NPS 2001B

Statement on behalf of Langage Construction Ltd

LINE OF SIGHT

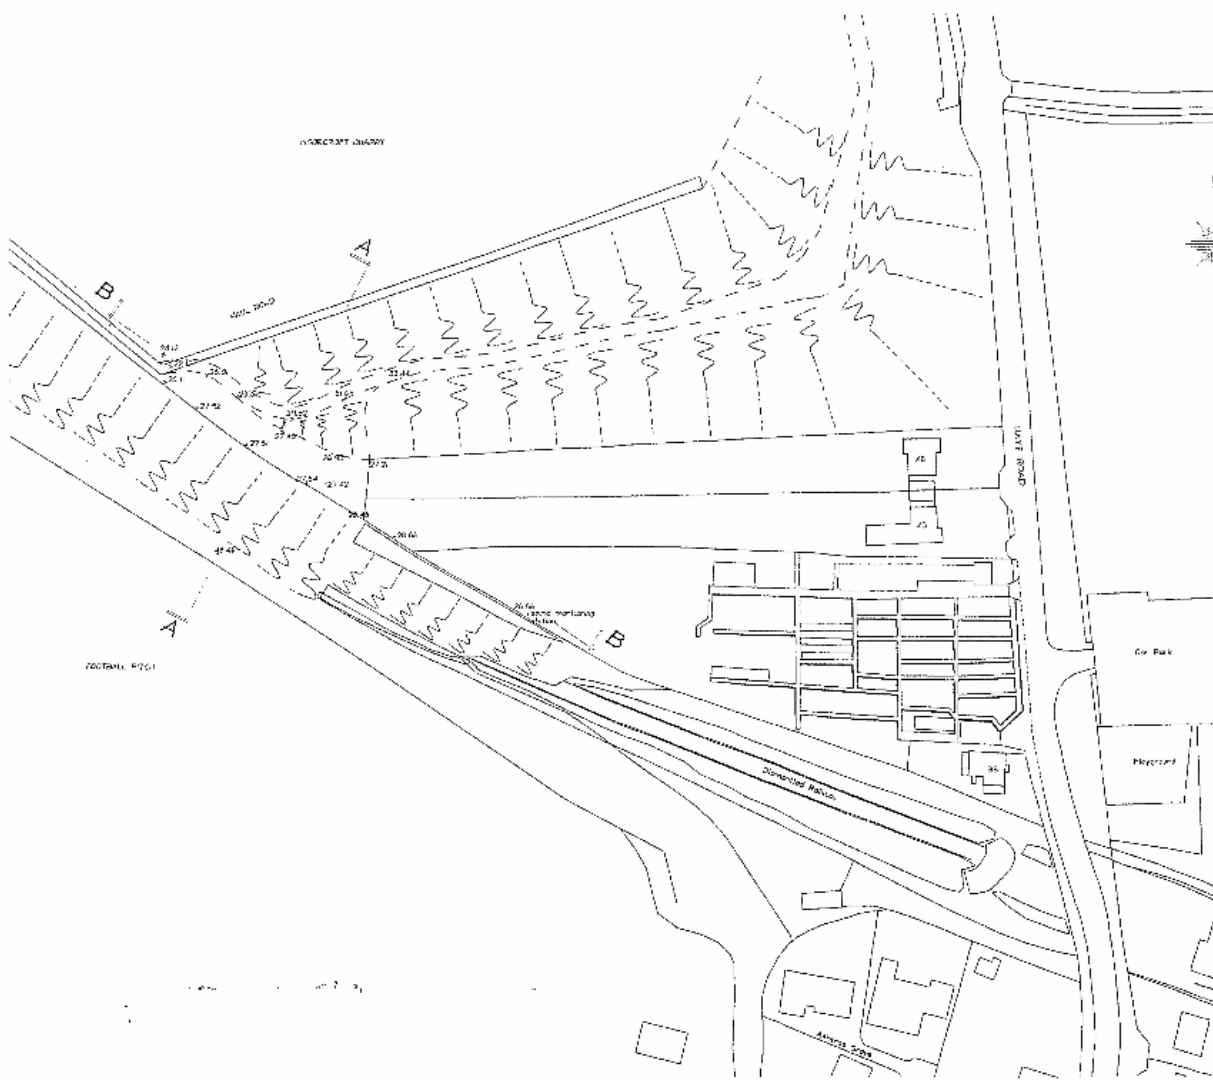
Sections taken through the site to counter the incorrect assertion given at para 13 of PCC's proof that there is no direct line of sight between the monitoring equipment used in Ian Sharland's report and the haul road within the boundary of the quarry.

The sections show that there is an existing direct line of sight, the conclusion being that the HQPT will make minimal difference.

The Council's assertion was that there is no direct line of sight, therefore the noise impact statement is an irrelevant consideration for when the HQPT breaches the existing noise attenuation bund.
